## Executive Director's Recommendation

Commission Meeting: July 9, 2015

<b>PROJECT</b> <b>Vietnam Veterans Memorial Visitor Center</b> Lincoln Memorial Washington, DC	<b>NCPC FILE NUMBER</b> 6597  <b>NCPC MAP FILE NUMBER</b> 1.43(38.00)44167
<b>SUBMITTED BY</b> United States Department of the Interior National Park Service	<b>APPLICANT'S REQUEST</b> Final approval of site and building plans
<b>REVIEW AUTHORITY</b> Approval per 40 U.S.C. 8903, 40 U.S.C. § 8905, and 40 U.S.C. 8722(b)(1) and (d)	<b>PROPOSED ACTION</b> Approve as requested  <b>ACTION ITEM TYPE</b> Staff Presentation

Figure 3: Final site plan for the Visitor Center

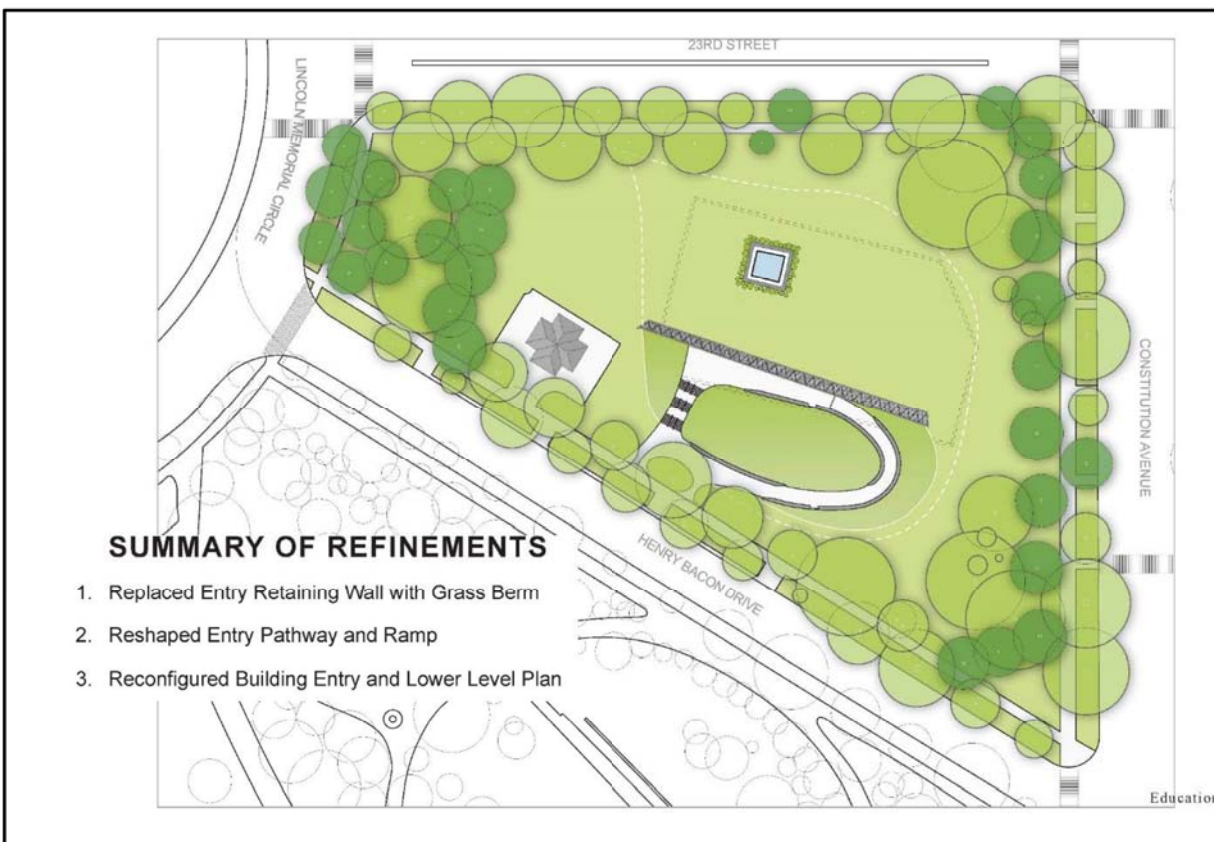
Modifications to the Visitor Center since the Commission's preliminary approval are in response to comments, concerns, and suggestions from the Commission as well as the U.S. Commission of Fine Arts (CFA) and other interested stakeholders. To satisfy life safety and egress concerns of NPS code officials, a second means of egress was added to the entry path. The final site plan incorporates two means of entry and exit from the Henry Bacon Drive sidewalk.

Comments concerning the similarity of the form of the Visitor Center (two perpendicular walls) to the Vietnam Veterans Memorial, necessitated other changes to the design. The retaining wall adjacent to the entry stair has been removed, and a gradual grass berm at a 3:1 slope has been incorporated into the landscaping. In order to realize the minimum slope of the lawn down to the lower plaza and have room to enter the building, the building shifted 22 feet to the north. The exterior stair remained in the same position. In order to protect the sloped lawn, the horizontal rail increased in size by approximately 22 feet to the north and 23 feet to the south and its total length is now 248 feet. The entry doors to the building were also relocated so that the doors are on axis with the entry stair. In the preliminary plans approved by the Commission, the entry doors were not on axis with the stair, but were adjacent in a covered "forecourt". Due to removal of the retaining wall and the changes to the entry, there were also modifications to the entry and lower level floor plans. However, the overall size of the building remains the same at 37,000 square feet.

In response to comments from the CFA in 2014, the grass berm defined by the surrounding entry ramp has been reshaped. In the final plans, this berm takes on an organic shape rather than an ellipse. CFA's comments indicated that the form of an ellipse was inwardly focused and did not respond to the open curves of other areas along the National Mall such as Constitution Gardens and the linear geometry of the Lincoln Memorial.

Figure 8: View of the Visitor Center from the Lincoln Memorial

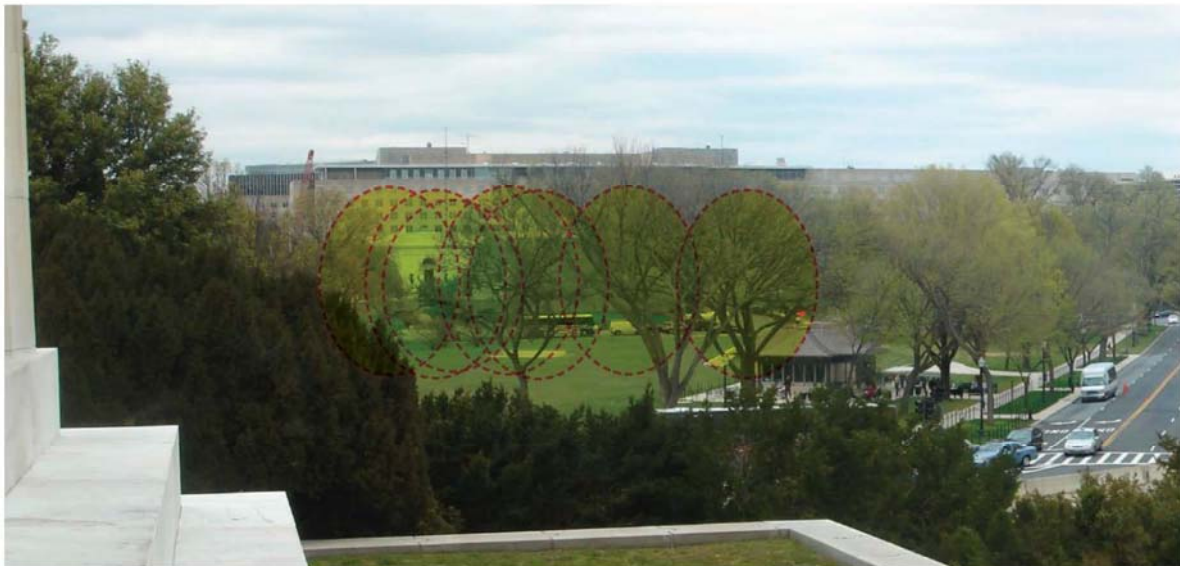
The Visitor Center has been designed as an underground facility. Portions of the courtyard and horizontal rail are visible from the Lincoln Memorial steps and podium. Though these elements will be visible, trees to be planted as part of the landscape plan for the project will help mitigate the impact on the view. By incorporating a curved entry ramp that surrounds a green berm, the visibility of the sunken entrance from the surrounding streets has been minimized and reduced the impact that the Visitor Center will have on the landscape. In addition, by raising the grade of the site and with the design of a green roof to cover a portion of the courtyard, the Visitor Center will be minimally visible from the intersection of Constitution Avenue and 23<sup>rd</sup> Street. While a portion of the Visitor Center (horizontal rail) will be visible from Henry Bacon Drive, the building does not dominate the view shed.

Figure 11: Proposed grade change

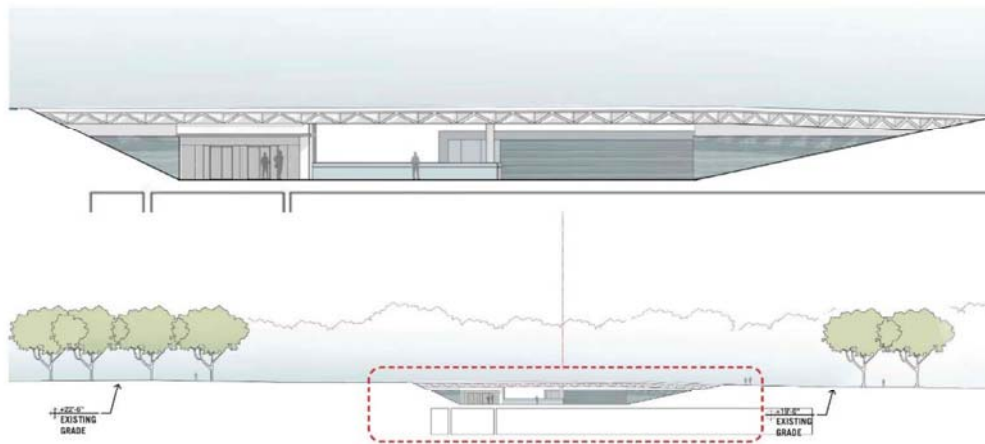
As was proposed in the preliminary plans, the design of the Visitor Center will raise the grade of the site by 3'6" in order to accommodate the curved entry ramp. The entryway to the Visitor Center will be at an elevation of 7' and the slope of the curved ramp is gradual in order to descend from the top of the ramp at an elevation of 20' AMSL. While the grade is proposed to be raised, it is to allow an accessible entry ramp and the character of the landscape will be maintained.

Figure 13: Tree protection plan

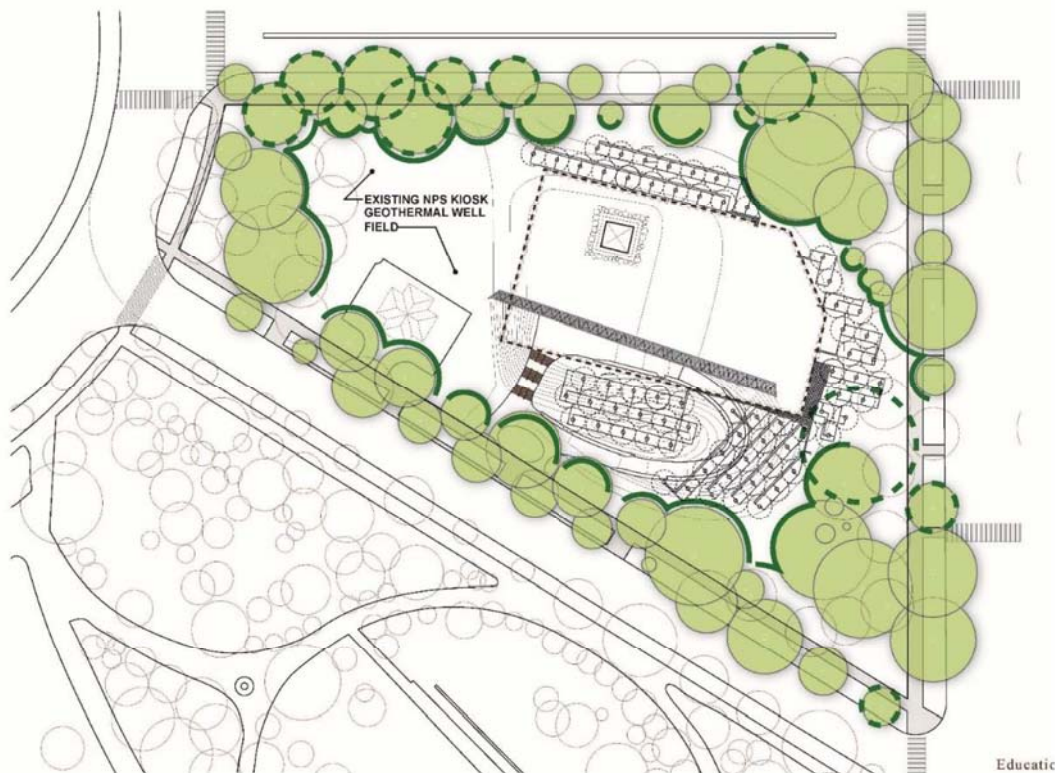
The Visitor Center will be constructed outside of the critical root zone of the existing elm trees. The applicant has developed a tree protection plan to preserve the existing trees on the site both during and after construction.

Figure 14: Detail of ha-ha condition at courtyard opening

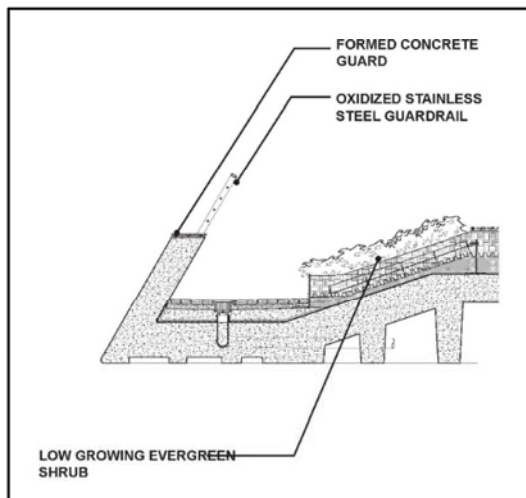
The design of the Visitor Center incorporates a horizontal rail along the edge of the green roof to protect against potential falls. The horizontal rail eliminates the need for vertical guardrails. The ha-ha condition around the courtyard opening features a concrete guard wall capped with an oxidized stainless steel guardrail. These elements were both included in the preliminary plans, and though they will be visible, the number of vertical elements has been kept to a minimum.

Figure 16: Detail of horizontal rail

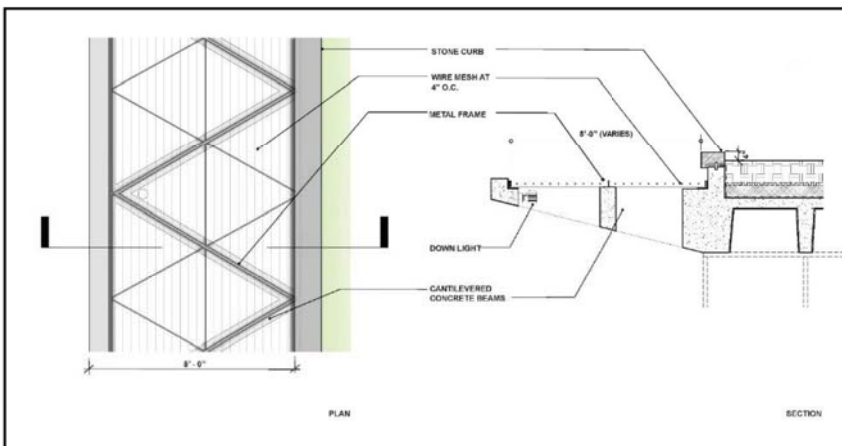
The horizontal rail has increased in size by approximately 45 feet since the Commission approved the preliminary plans and will be approximately 248 feet in length. The increase in length is needed to protect the 3:1 slope that has replaced the retaining wall adjacent to the entry stairs (on the south). The horizontal rail increased by 23 feet to the south and approximately 22 feet to the north to protect the slope. In exchange for a larger horizontal rail, the Visitor Center has only one façade and its form is distinct from the Vietnam Veterans Memorial. This modification was specifically made in response to CFA comments concerning the similarity of the Visitor Center (preliminary

Staff notes that the color and finish of the horizontal rail is critical to minimizing its visibility particularly given its increase in size. Staff has requested that the National Park Service continue to work with the design team and appropriate review agencies regarding the finish and color of this element. The National Park Service has agreed to consult further on the final finish and color of the horizontal rail and staff is recommending that the Commission **notes the National Park Service will review the final finishes and color selection of the horizontal rail in consultation with review agency staff, as appropriate, to ensure compatibility with the surrounding context and minimize its appearance.**

**Notes** the National Park Service will review the final finishes and color selection of the horizontal rail in consultation with review agency staff, as appropriate, to ensure compatibility with the surrounding context and minimize its appearance.
